# RENESAS TECHNICAL UPDATE

Product Category	System LSI		Document No.	TN-USB-A0006A/E	Rev.	1.00
Title	μPD720201 External Serial ROM Connection circuit update		Information Category	Technical Notification		
Applicable Product	μPD720201K8-701-BAC-A μPD720201K8-701-BAC-M1-A	Lot No.	Reference Document	μPD720201/μPD720202 Data Sheet (R19DS0047) μPD720201/μPD720202 User's Manual: Hardware (R19UH0078)

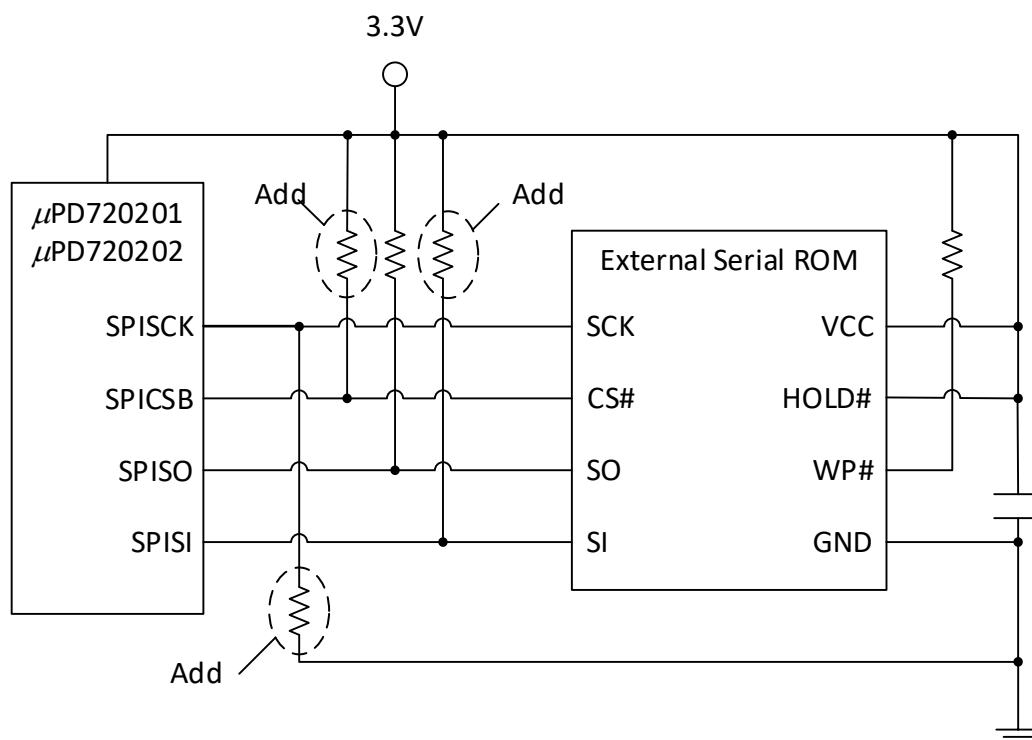
The new recommended circuit is as the following figure.

- A. Adds the pulldown resistor on SPISCK
- B. Adds the pullup resistor on SPICSB
- C. Adds the pullup resistor on SPISI

Figure 2. new  $\mu$ PD720201 external serial ROM connection circuit

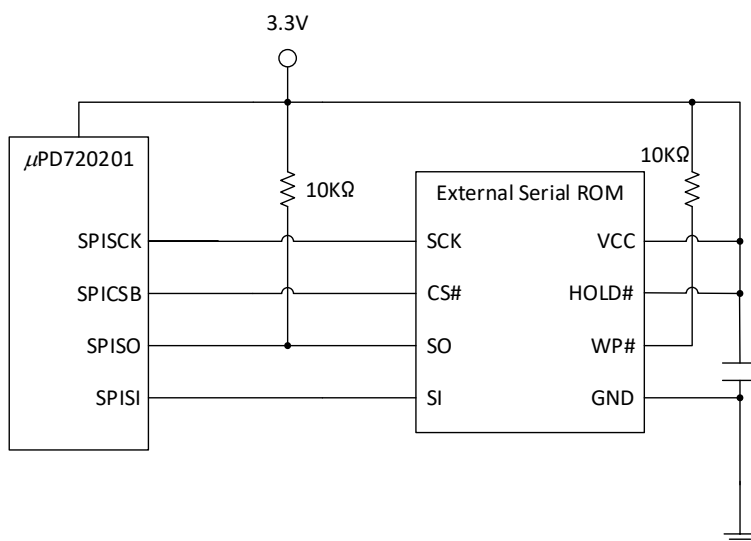
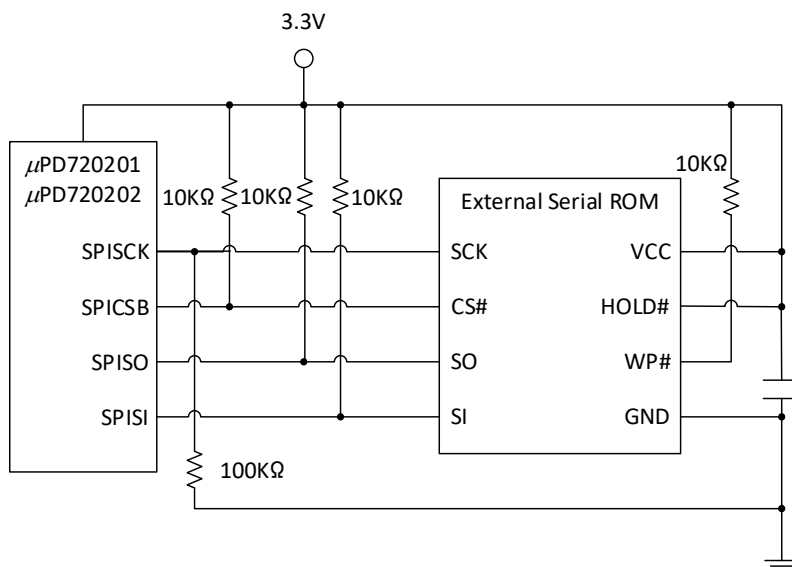
Renesas was informed that μPD720201 SPICSB behavior does not meet the external serial ROM datasheet specification with the following Figure 1 when μPD720201 and external serial ROM are powered.

According to some of external serial ROM datasheet, CS# pin basically needs to be ramped up/(down<sup>Note1</sup>) with VCC

at the same time. On the other hand,  $\mu$ PD720201/ $\mu$ PD720202 SPICSB drives low to high when PERSTB pin is deasserted (i.e. PERSTB=high) i.e. SPICSB=Low during external serial ROM VCC power up.

Will update the external serial ROM connection figures in  $\mu$ PD720201/ $\mu$ PD720202 User's Manual: Hardware (R19UH0078) as the following Figure 2 which is same as [TN-USB-A0004A/E](#) in order to meet serial ROM datasheet spec.

**Note:** The 3.3 V that pulls SPICSB/SPISO/SPISI must be the same as the 3.3 V supplied to the  $\mu$ PD720201/ $\mu$ PD720202
